Applicant: Julie Long; City of Bloomington
Consultant:
Project: Normandale Lake Bank Stabilization
Location: West 84th Street and Normandale Boulevard: Bloomington
Rule(s): 2,5, and 7
Reviewer: BCO

Permit #: 2018-139
Project Name: Maintenance of Normandale Lake Shoreline Protection: Bloomington
Approval Date: January 16, 2019

Figure 1

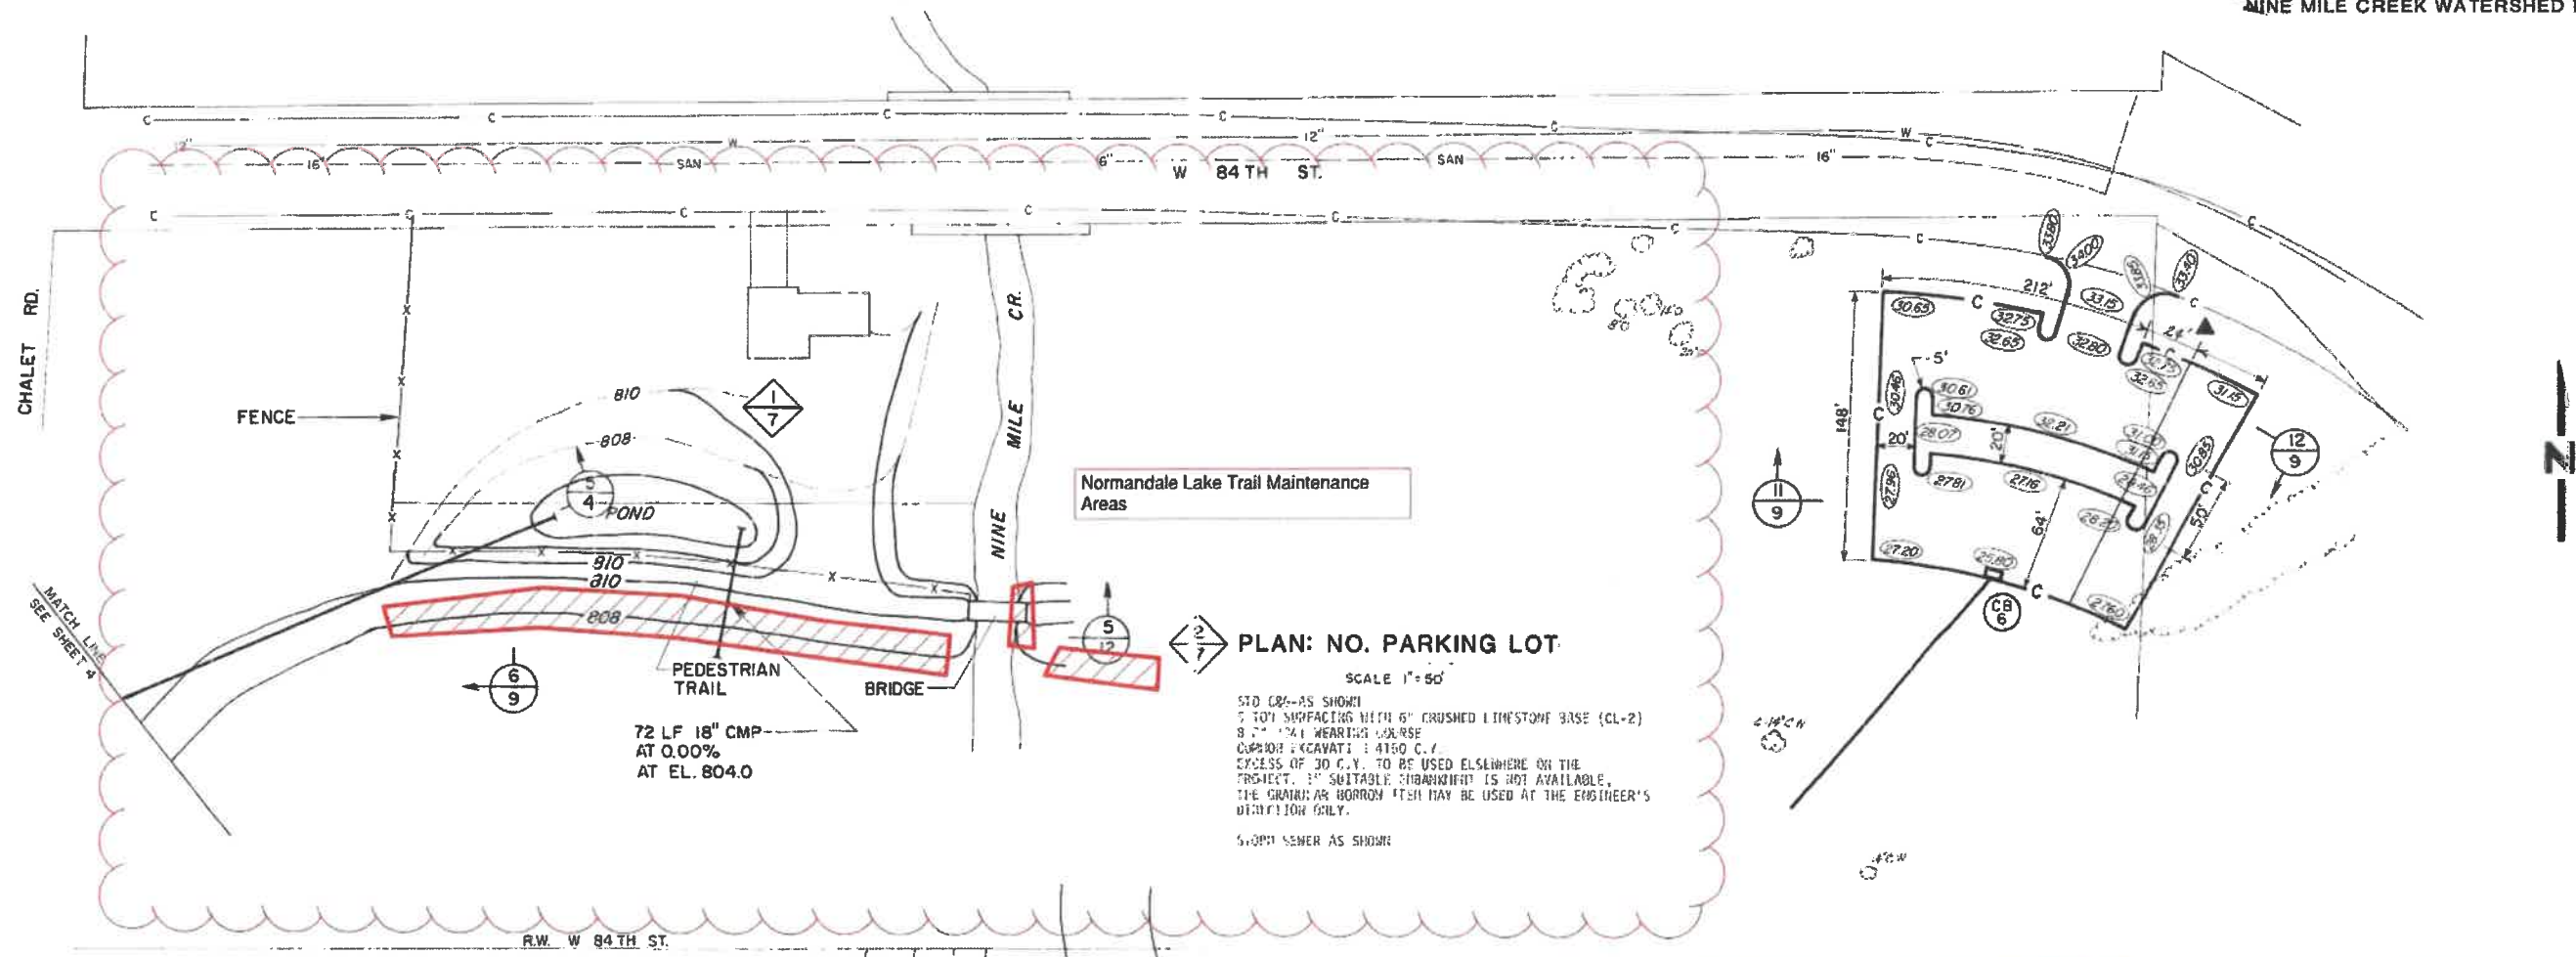
The plans show the stabilized shoreline at a slope of 5:1.
